City of Alexandria, Virginia

SUBJECT: DSUP #2004-0001 – THE PRESCOTT

Docket Item #13
DEVELOPMENT SPECIAL USE PERMIT #2004-0001
THE PRESCOTT (Hopkins Warehouse)

ISSUE: Consideration of a request for a development special use permit, with site plan and modifications, for construction of a residential condominium building with underground parking.

Figure 5 - Staff and BAR Proposal - Cameron Street

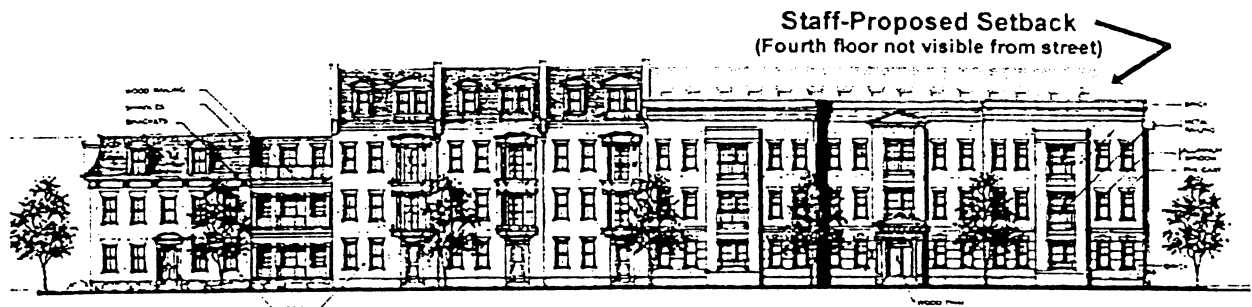
The remaining area of concern for staff, as well as the Parker Gray Board, is the scale of the building at the intersection of Henry Street and Cameron Street and the northern portion of the building on Henry Street. Therefore, staff recommends that a portion of the building be set back at the corner of Cameron and Henry Street so that the fourth level will not be visible, as depicted in Figure 5, and that the northern portion of the facade on Henry Street be revised as depicted in Figure-16. These proposed changes will likely result in the elimination of some of the units or a change in the number of one and two bedroom units. These revisions are necessary to ensure that the proposed building is compatible with the existing two- and three-story buildings on Henry Street. In addition to reducing the overall height, the proposed modifications provide additional variation in the rooflines and greater building articulation, both of which help to reduce the perceived mass of the building. With these changes, the overall massing will reflect the comments of the BAR and can be supported by staff.

Figure 11 - Fayette Street Elevation

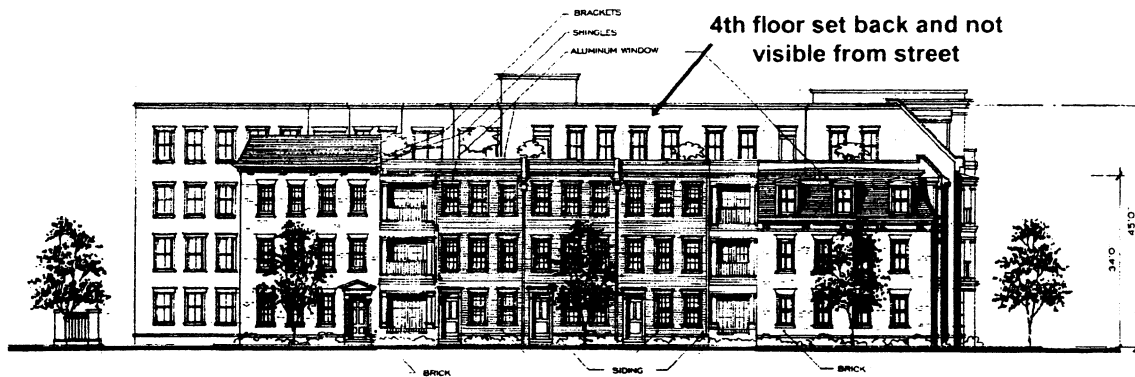
Staff recommends the following changes to the Fayette Street elevation:

Figure 13 - Staff Proposal - Cameron Street

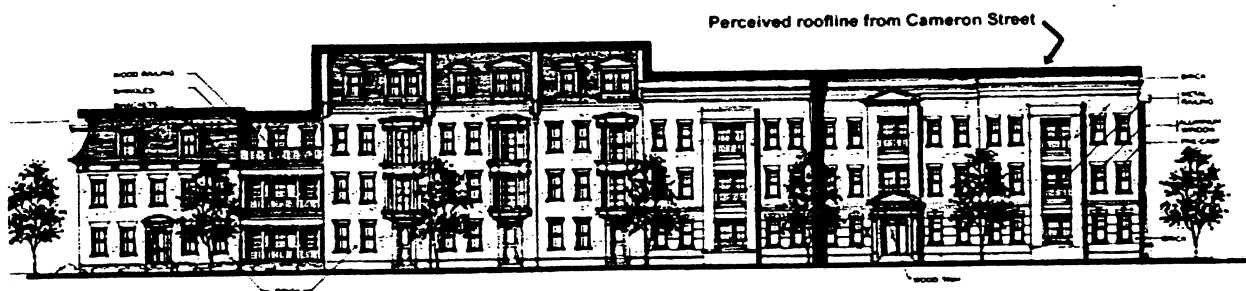
The following changes to the Cameron Street elevations are also recommended:

- The balcony-hyphen shall be revised to be subservient to the single-family building.
- The fourth level balconies for the three central townhomes shall be converted to dormers.
- The two-story balconies for the three central townhomes shall be converted to enclosed balconies consistent with the architectural style of the units.
- The eastern portion of the facade shall be revised per Condition #2.
- The setback for the hyphen shall be at least 8 feet, recessed behind the adjoining building faces, and the balconies shall either be flush with or recessed behind the adjoining building faces.

With these revisions the facade will appear to be two- to three-story, consistent with the character of the historic district. The proposed revisions to the mass also provide more variation in the roof heights, further reducing the perceived mass and scale of the proposed building.

**Fig 15 - Massing Study
(Proposal in Pink)**

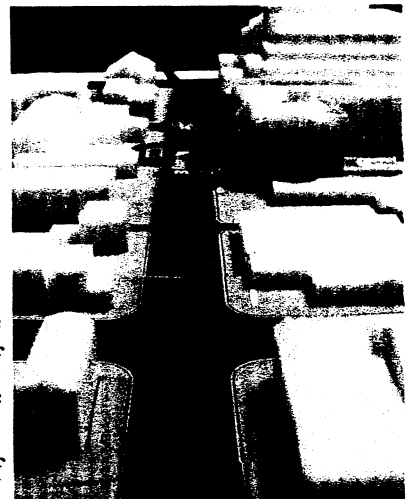
The other concern raised by the Parker Gray Board and shared by staff is the perception of the northern portion of the building on Henry Street. The proposed three- to four-story element is significantly larger than adjoining buildings and will provide an inappropriate transition to the adjoining Bradham auto repair facility. While the Bradham property may redevelop in the future, the northern portion of the building needs to be designed at a scale that is appropriate for the existing condition rather than an assumed future condition. The scale is also significantly greater than the adjoining two- to three-story buildings on Henry Street. For all of these reasons, staff is recommending that the north end of the building be reduced to three stories to provide a better transition. The scale and height of the proposal, even with the staff recommendations, will be considerably more than the one-story gas station and two-story building that are on the site today.

Figure 16 - Staff Proposal - Henry Street

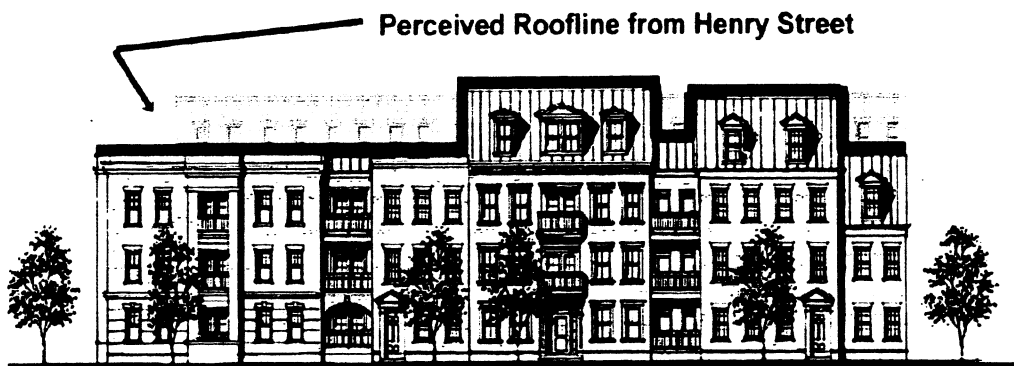
As previously discussed, this facade is the one to which significant revisions need to be made before the mass and scale are compatible with the existing character of Henry Street. As with the Cameron Street facade, staff recommends that the building be designed to appear as a three-story building and that a portion of the building be redesigned with more townhouse bays as generally depicted in Figure 16.

Figure 17 - Landscaping Plan

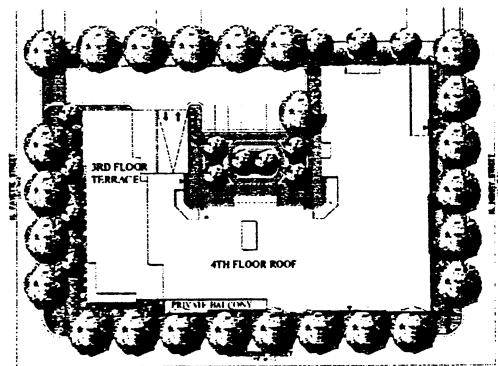
Staff has concerns regarding open space that are related to both quantity and quality. To address the issue of quality, additional landscaping, irrigation and amenities such as benches are recommended to make the ground-level open space more useable and attractive. In addition, staff recommends that the four parallel, at-grade parking spaces be eliminated, that all of the surface parking spaces be compact spaces, and that two additional 90° parking spaces be added. This reconfiguration will result in the net loss of two parking spaces, but will provide additional open space, increase the buffer from the adjoining auto repair facility, and increase the amount of visible open space from Fayette Street.
